69 Airbag warning light on, DTCs B100A1B, B100B1B

69 23 05 2072349/1 December 13, 2023.

Model(s)	Year	VIN Range	Vehicle-Specific Equipment
Q5, Q5 e quattro, and SQ5	2020 – 2023		
Q5 Sportback, and SQ5 Sportback	2021 - 2023	All	Not Applicable

Figure 1. Install additional zip tie/clip when installing new thorax airbag wire harness.

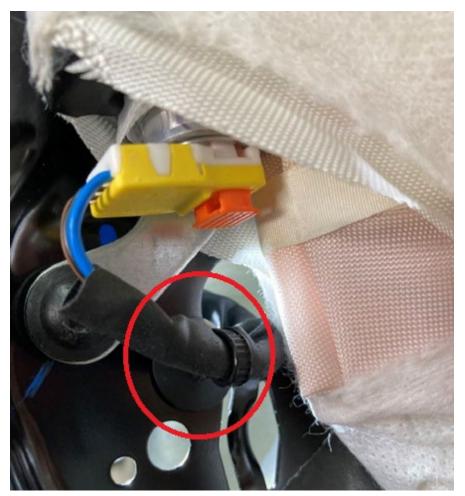
The wire harness of the side/thorax airbag is too close to the seat foam. The seat foam presses on the wire harness causing movement of the airbag connector, resulting in an increase in electrical resistance.

- 1. Replace the affected side/thorax airbag wire harness(es) according to: Elsa>>Repair manual>>Body>>Body Interior>>Passenger Protection, Airbags, Seat Belts>>Thorax Airbags>>Thorax Airbag Wire, Removing and Installing.
- Route the new thorax airbag wire harness(es) as close to the seat frame as possible. To do so, use zip tie/clip N10546701 (Figures 1, 2).
